Meeting minutes

Meeting: Great Jackson Street, Crown Street Phase 3 and Plot D –
Fire Safety Design Review

Date: 30/11/2022
Time: 10.30am

Figure 1 – Towers C7 and C8 indicative core arrangement

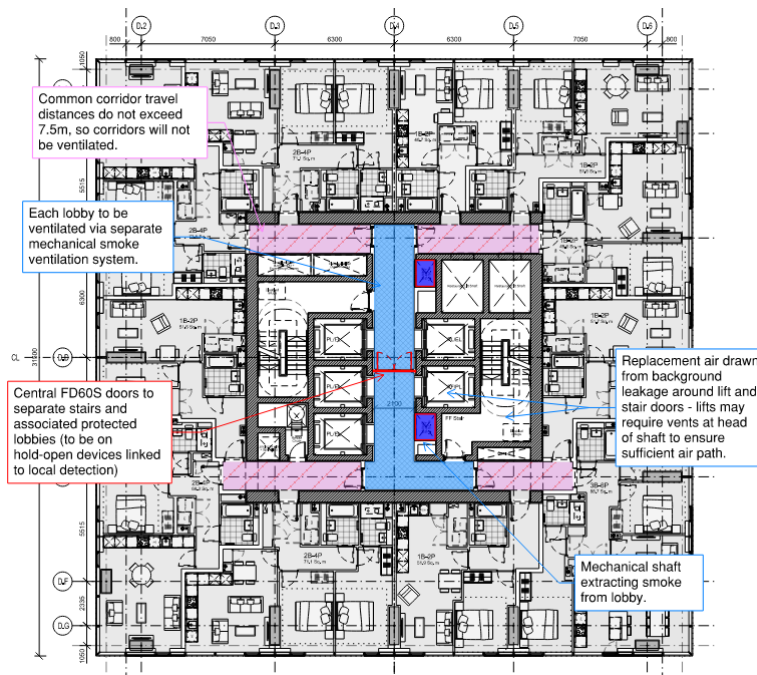
3.2	GMFRS and MCC BC confirmed that they will require the doors separating the lobbies of the adjacent stair cores in each building to be retained as currently shown (regardless of what the final recommendations of the updated BS 9991 are) and requested that these doors are provided with hold-open devices, linked to localised smoke detection, so that they are not 'damaged' through daily use (i.e. held open in all but fire conditions).

3.3	AS outlined ventilation provisions for towers C7 and C8 as follows: - Each stair/lift lobby will be ventilated by means of a single mechanical smoke extract shaft, activated by smoke detection within the associated common corridor and lobby (i.e. system in each half of floor activates independently). - Each extract shaft system will incorporate pressure sensors and a fan inverter, so that extract rates can be ramped up and down to prevent excessive pressure differentials. - Replacement air to ventilated lobby will be drawn from leakage around stair and lift doors - AOV to be provided at head of stair and vents may be required to lift shafts to increase background leakage (TBC as part of system design). - As the common corridor travel distances do not exceed 7.5m, they will not be ventilated, in line with BS 9991 guidance for ventilated sterile lobby arrangement.
